9-10N-46W
water wells in area

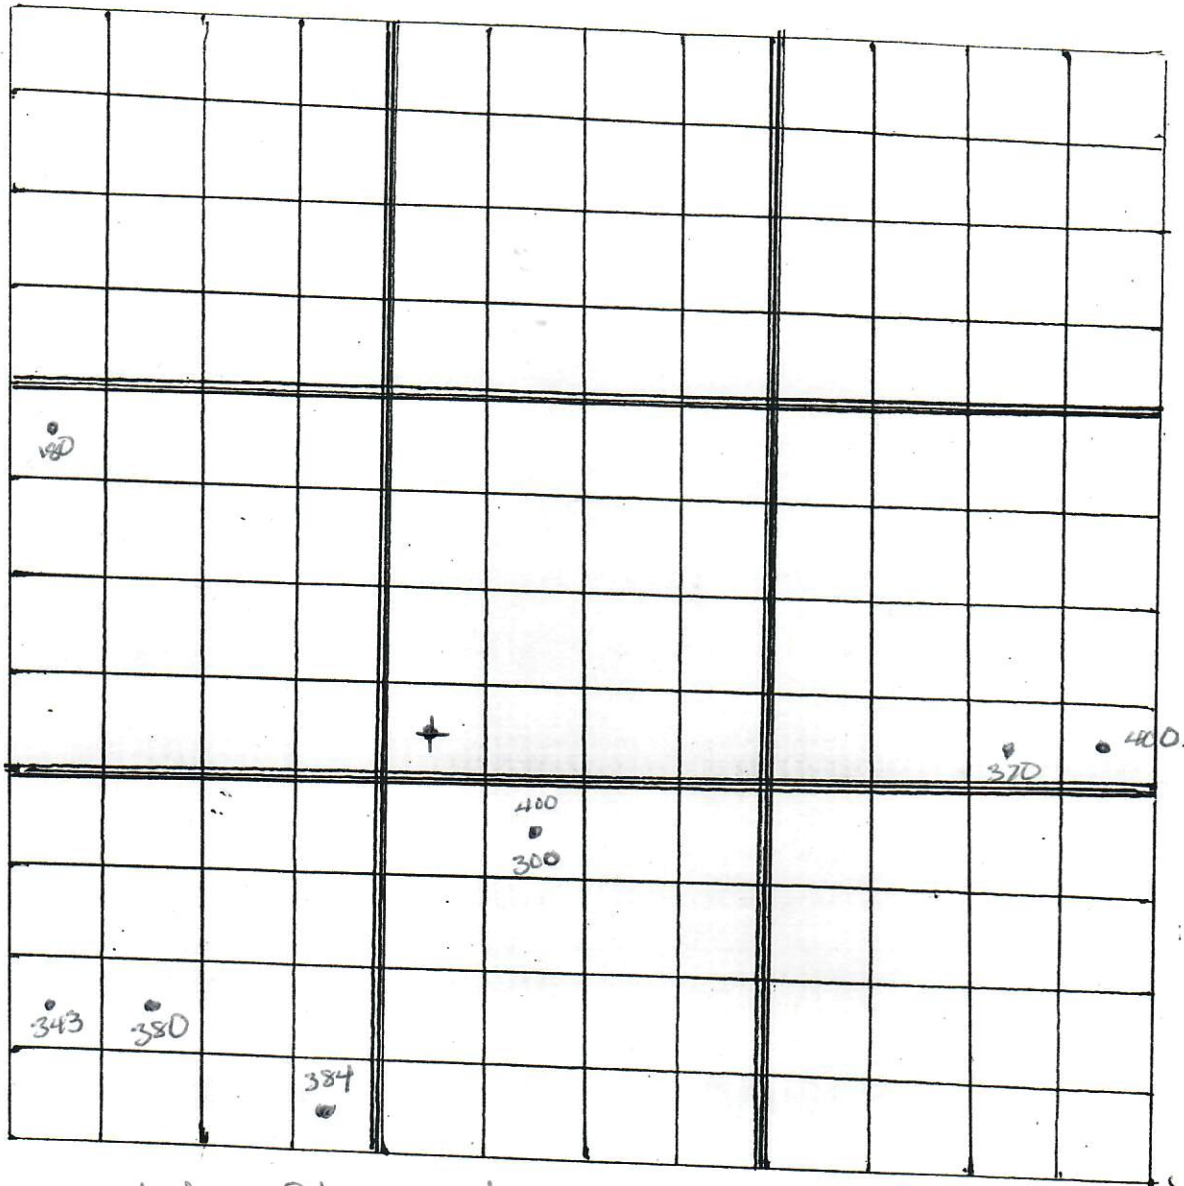
Called Steve James 9/9
requested DIL across surface casing shoe
if available. COGCC does not have it.
to determine if ~~the~~ additional cementing
requirements needed if production casing
is set. 9/13/94

DIL of upper hole could not be found

per
Steve
James
